Access Compliance Report

Public Rights-of-Way

(Curb Ramps)

Intersection ID: 2773	Main Street: EASTFIELD_RD	Cross Street: FOGGY_MEADOW_RD	Location: S
ADA ID: 82E290741994	Ramp Type: Perp	Initial Pass/Fail: Fail	Overall Compliance: No
Severity Score: 12.5			
Codes/Mitigation Info/Possible Solution		Field Measurements/Component Compliance

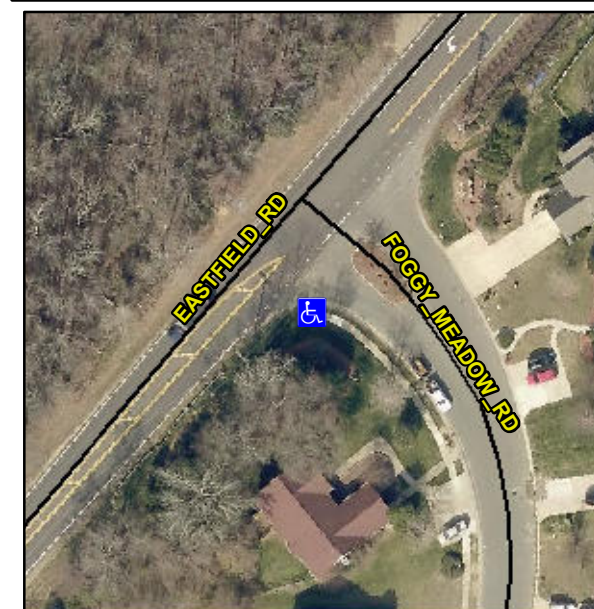
Not Found, R304.2.2

Compliance	Description	Data	Compliance	Description	Data
N/A	Ramp Length (in)	49.0	No	Ramp Slope (%)	10.6
Yes	Ramp Width (in)	52.0	Yes	Ramp XSlope (%)	1.7
N/A	Flare Type LT	N/A	N/A	Flare Type RT	N/A
N/A	Flare Slope LT (%)	N/A	N/A	Flare Slope RT (%)	N/A
N/A	Flare Traversable LT?	N/A	N/A	Flare Traversable RT?	N/A
N/A	Landing Length (in)	N/A	N/A	DWS Provided?	N/A
N/A	Landing Width (in)	N/A	N/A	DWS Contrast?	N/A
N/A	Landing Slope (%)	N/A	N/A	DWS Length (in)	N/A
N/A	Landing X Slope (%)	N/A	N/A	DWS Full Width?	N/A
N/A	Landing Curb? (Y/N)	N/A	N/A	DWS Offset (in)	N/A
N/A	Shared Landing?	N/A			
N/A	Gutter Ponding?	Yes	N/A	Gutter Slope (%)	N/A
N/A	Gutter Lip Ht (in)	N/A	N/A	Gutter X Slope (%)	N/A
N/A	Painted X Walk1?	No	N/A	Painted X Walk2?	N/A
	X Walk 1 Direction	To NE		X Walk 2 Direction	N/A
N/A	X Walk 1 Width (in)	N/A	N/A	X Walk 2 Width (in)	N/A
	X Walk 1 Slope (%)	1.1		X Walk 2 Slope (%)	N/A
	X Walk 1 X Slope (%)	1.4		X Walk 2 X Slope (%)	N/A

Remove & Replace Entire Ramp.
